# Comments 195, 196, 197, 198: Link Sync State Diagram

G. Zimmerman / CME Consulting

Revised 3/9/2026

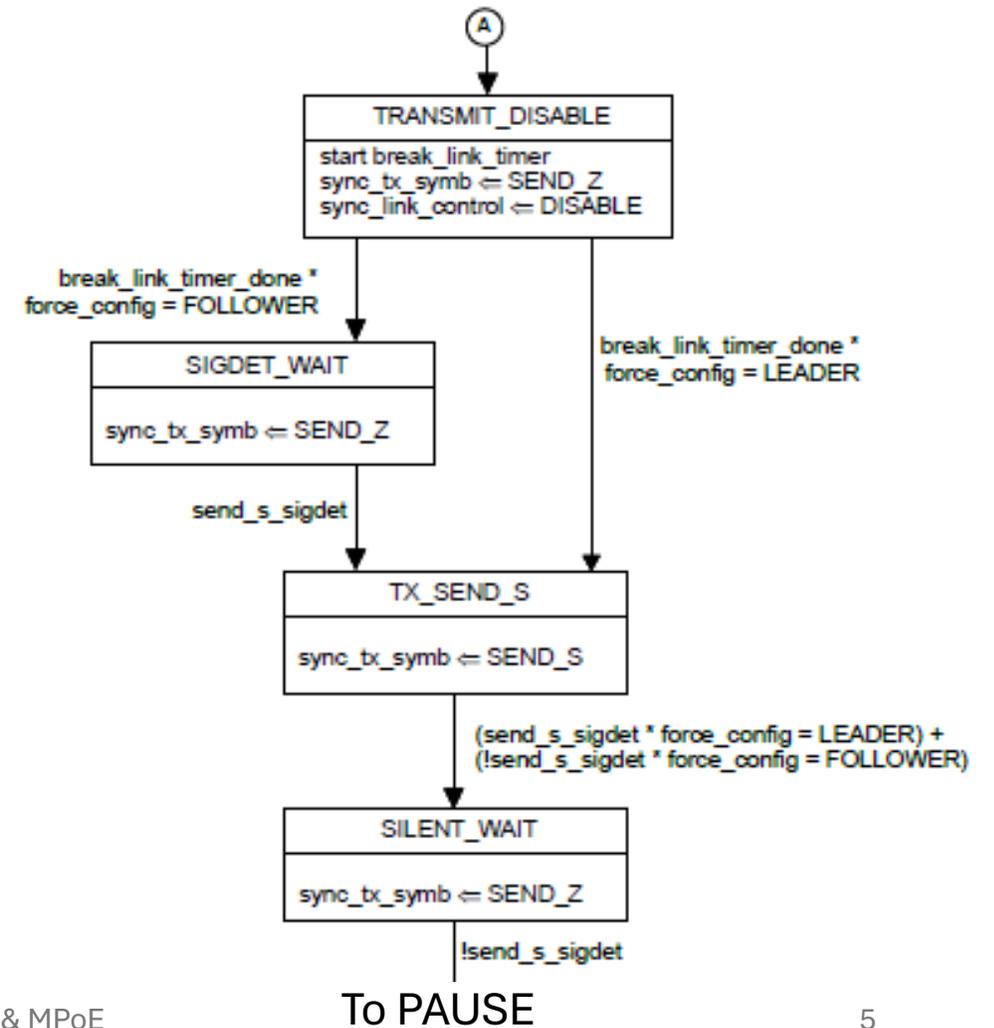
ID	Commenter	CommenterCo	Subclause	Page	Line	Comment	SuggestedRemedy	
195	Zimmerman, George	CME Consulting/ADI,APL Gp, Cisco, Infineon, OnSemi, Sony	201.5.2.10	120	4	This section describes the link synchronization, but lacks the simple requirement that the state diagram (Figure 201-26) shall be followed.	Change "shall establish the start of PHY PMA training as defined in 201.5.2.7." to "shall conform to the state diagram in Figure 201-26. This section describes and defines the function of Figure 201-26, the link synchronization process."	
197	Zimmerman, George	CME Consulting/ADI,APL Gp, Cisco, Infineon, OnSemi, Sony	201.5.2.10	120	40	The 5th paragraph here has shalls which duplicate what is in the state diagram. They should be replaced by descriptive text.	Replace "shall output" at lines 42 and 44 with "outputs"  Replace "shall repeat" at line 45 with "repeats"  Replace "shall stop outputting and enter" at lines 46-47 with "stops outputting and enters"  Replace "shall also enter" at line 48 with "enters"

196	Zimmerman, George	CME Consulting/ADI,APL Gp, Cisco, Infineon, OnSemi, Sony	201.5.2.10	120	41	The text here includes a delay for the FOLLOWER sending out a SEND_S pulse that conflicts with the state diagram. Assuming this is the intended behavior, the state diagram needs to be corrected.	<b>SEE THIS PRESENTATION</b>	
198	Zimmerman, George	CME Consulting/ADI,APL Gp, Cisco, Infineon, OnSemi, Sony	201.5.2.10	.1	122	1	The conditions for what TRUE and FALSE mean are contained as 'shalls' in the variable description for send_s_sigdet. Since the state diagram is one 'shall' this makes it a redundant requirement, and isn't good style.	Delete Text (2 sentences) from "At least 3 consecutive... to "setting this variable from TRUE to FALSE".  Change definitions of TRUE and FALSE to:  TRUE: At least 3 consecutive valid SEND_S pulses have been detected. FALSE: No SEND_S pulses have been detected for at least 3.1 us.

ID	Commenter	Affiliation	Subclause	Page	Line	Comment	SuggestedRemedy
115	Jonsson, Ragnar	Infineon	201.5.2.10.1	122		The description "At least 3.1µs period with no SEND_S pulses detected shall be detected before setting this variable from TRUE to FALSE" can lead to the state machine staying erroneously in the SEND_S state, in the presence of EMI pulses.	Change "At least 3.1µs period with no SEND_S pulses detected shall be detected before setting this variable from TRUE to FALSE" to "If less than three pulses are detected within a 5.1us period, the send_s_sigdet transitions from TRUE to FALSE"

# Comment 115

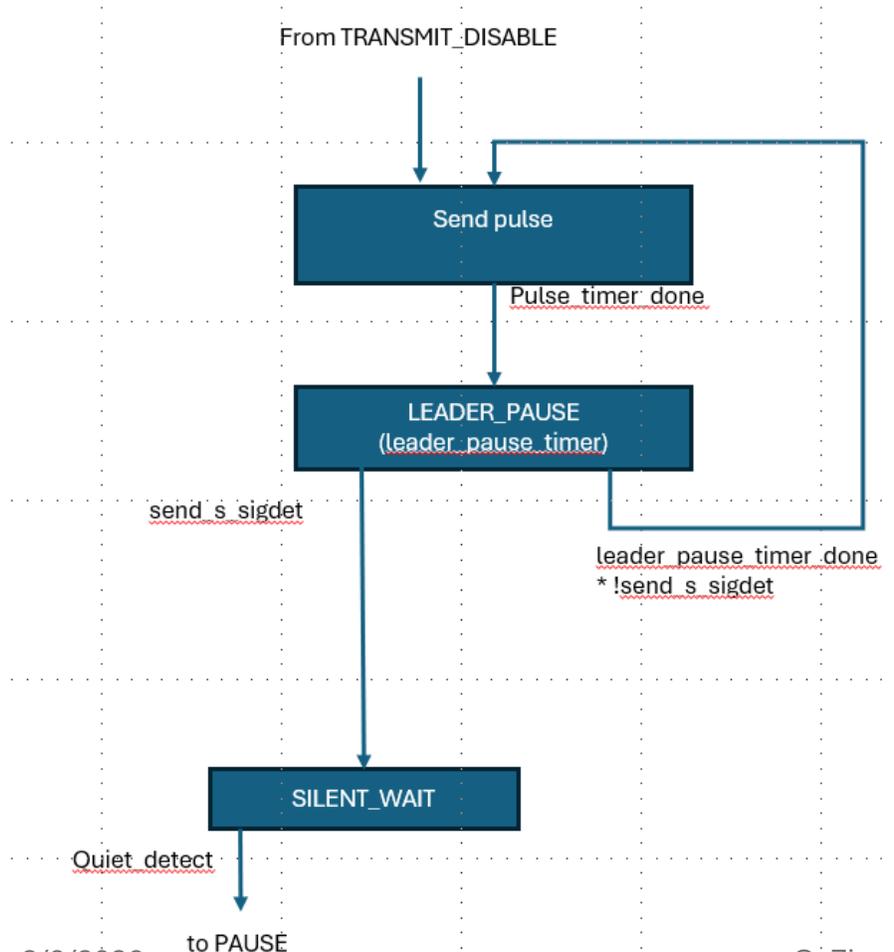
- Comment 115 changes the transition condition for detecting that the link partner has transitioned to SEND\_Z to detecting a specific number of pulses within a specific time.
- This removes the issue where a single missed pulse can cause a link partner to advance to the next state (or fall through a state)
- The suggested resolution of comment 115 is incorporated into the solution proposed here

Figure 201–26—PHY Link Synchronization state diagram

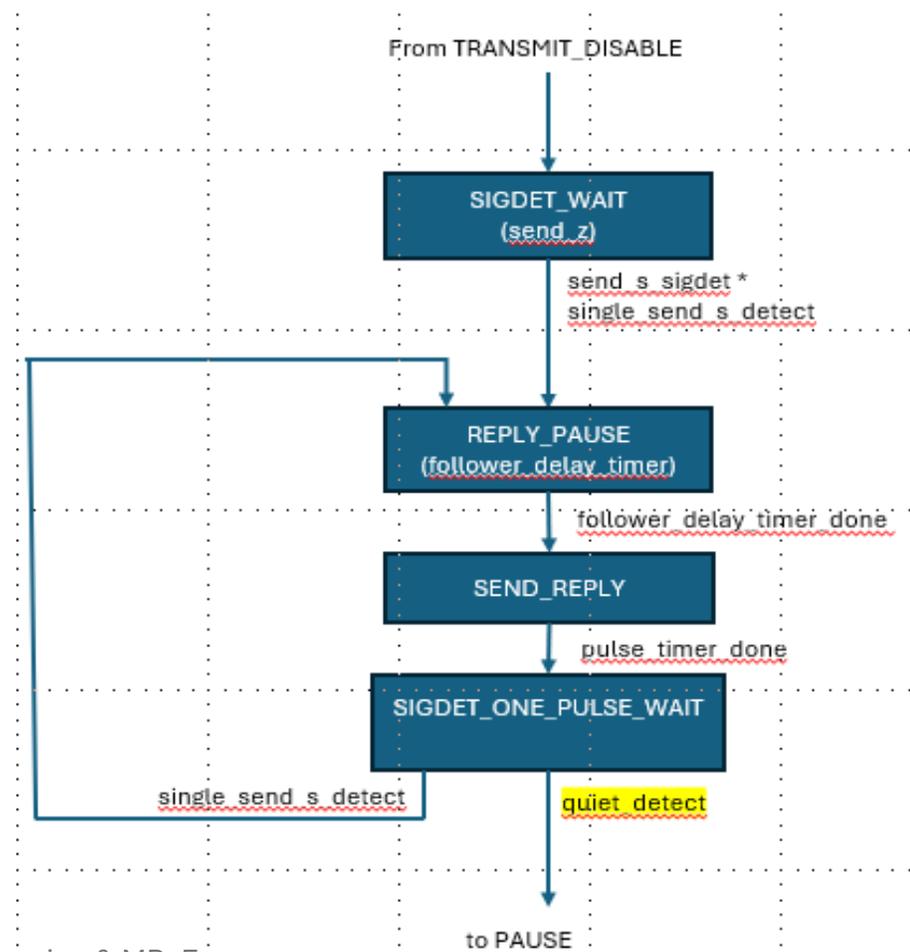
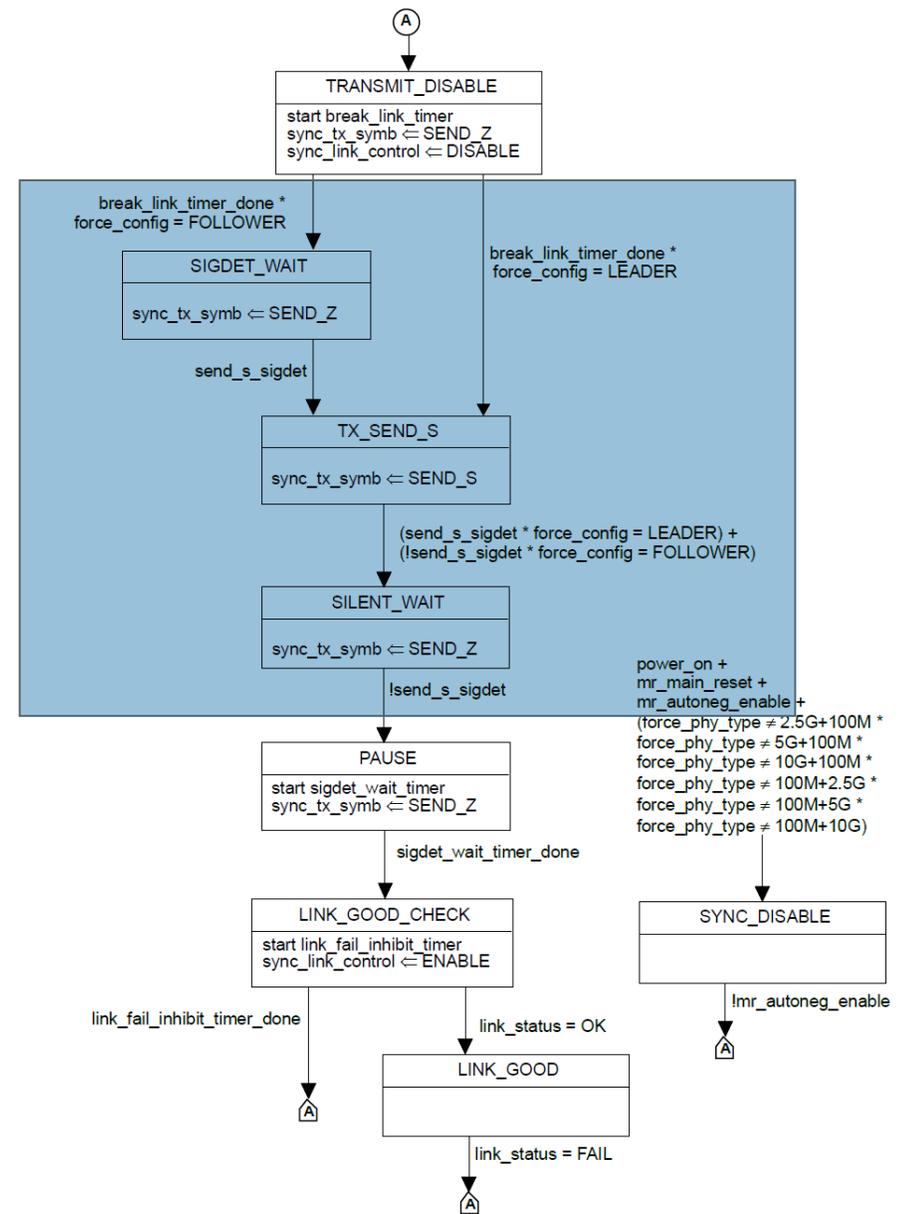
- 201.5.2.10 contains both a textual description of the Link Sync Process and the formal description of the State Diagram
  - They do not describe the same behaviour for the progress of detecting the link\_sync until entry to PAUSE
- The text describes its behavior with “shalls”, which are duplicative of the state diagram’s requirements
- SEND\_S is described both as a pulse and as a periodic pulse train
  - The use is different for the LEADER and the FOLLOWER...
- The behavior of the key variable, send\_s\_sigdet, is defined to be dependent on it’s state – mixing definition and state diagram

- Leader sends periodic SEND\_S
- Follower detects “a sufficient number” of pulses
- Follower outputs a single SEND\_S pulse with delay
- Follower then outputs a single SEND\_S pulse (with delay) for each subsequent pulse
- When Leader detects “a sufficient number” of follower’s pulses, it enters SILENT\_WAIT state & goes silent
- Follower detects Leader’s silence (unspecified criterion) and moves on to SILENT\_WAIT & goes silent
- Text does not describe further behavior (progress to PAUSE)

- Leader sends SEND\_S with each transmit clock
  - No mention of silence then repeating, is SEND\_S a pulse or a sequence of pulses?
  - Comment 113 would have “SEND\_S signal” & “SEND\_S pulse”
- Follower silently waits to detect 3 consecutive SEND\_S pulses
- Follower then begins sending SEND\_S
  - Overrides delay mentioned in text, and if SEND\_S is a sequence of pulses, this differs from text
- When Leader detects 3 consecutive SEND\_S pulses, enters SILENT\_WAIT state & goes silent
- When Follower misses the first SEND\_S pulse from the Leader, it enters SILENT\_WAIT and goes silent
- Follower will fall straight through SILENT\_WAIT to PAUSE
- Leader will proceed to PAUSE when it misses it’s first Follower SEND\_S pulse

- Add a new variable for detecting silence (incorporating comment 115) & modify send\_s\_sigdet
  - **quiet\_detect**: A Boolean variable that indicates whether the link partner has ceased sending SEND\_S pulses.  
VALUES:  
TRUE: No SEND\_S pulses have been detected at the specified times (for LEADER or FOLLOWER see Figure 201-25) within the preceding 5.1 usec.  
FALSE: At least one send\_s pulse has been detected at the specified times (for LEADER or FOLLOWER see Figure 201-25) within the preceding 5.1 usec

- Other new variables: single\_send\_s\_detect
- Add new timers: follower\_delay\_timer, leader\_pause\_timer, pulse\_timer
- Delete “shalls” in the descriptive text of 201.5.2.10

These two state chains go (as parallel vertical branches) replacing the states in the blue square in the PHY Link Synchronization state diagram at right.
